# Access Compliance Report

## Public Rights-of-Way

### (Curb Ramps)

Intersection ID: 7528	Main Street: LEMS福德_WY	Cross Street: SILCHESTER_LN	Location:	E
ADA ID: 36C33C845073	Ramp Type: Directional1	Initial Pass/Fail: Fail	Overall Compliance: No	Severity Score: 12.5

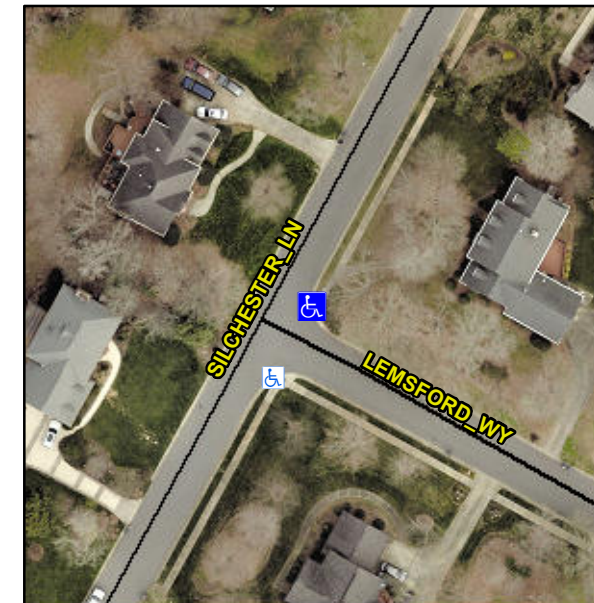
Compliance	Description	Data	Compliance	Description	Data
N/A	Ramp Length (in)	114.5	N/A	Grade Break?	N/A
Yes	Ramp Width (in)	48.0	N/A	Grade Break Slope (%)	0.0
Yes	Ramp Slope (%)	7.1	N/A	Grade Break XSlope (%)	0.0
No	Ramp XSlope (%)	6.7			
N/A	Flare Type LT	N/A	N/A	Flare Type RT	N/A
N/A	Flare Slope LT (%)	N/A	N/A	Flare Slope RT (%)	0.0
N/A	Flare Traversable LT?	N/A	N/A	Flare Traversable RT?	N/A
N/A	Landing Length (in)	0.0	N/A	DWS Provided?	N/A
N/A	Landing Width (in)	0.0	N/A	DWS Contrast?	N/A
N/A	Landing Slope (%)	0.0	N/A	DWS Length (in)	N/A
N/A	Landing X Slope (%)	0.0	N/A	DWS Full Width?	N/A
N/A	Landing Curb? (Y/N)	N/A	N/A	DWS Offset LT (in)	N/A
N/A	Shared Landing?	N/A	N/A	DWS Offset RT (in)	N/A
N/A	Gutter Ponding?	0.0	N/A	Gutter Slope (%)	N/A
N/A	Gutter Lip Ht (in)	0.0	N/A	Gutter X Slope (%)	N/A
N/A	Painted X Walk1?	No		Road Slope (%)	2.5
	X Walk 1 Direction	To SW		Road X Slope (%)	3.3
	X Walk 1 Width (in)	N/A		Clear Space?	N/A

X Walk 1 Slope (%)	2.5	N/A	Clear Space to XWalk (in)	N/A
	X Walk 1 X Slope (%)	3.3	N/A	Storm Grate/Utility Hazard?	N/A
N/A	Ramp inside XWalk1?	N/A		Storm Grate/Utility Type	
N/A	Any Obstructions?	N/A			N/A
	Obstruction Type		Yes	Surface Condition? (G/P)	Good
			N/A	Curb Slope (%)	9.0

**Remove & Replace Entire Ramp.**

**R304.5.3**
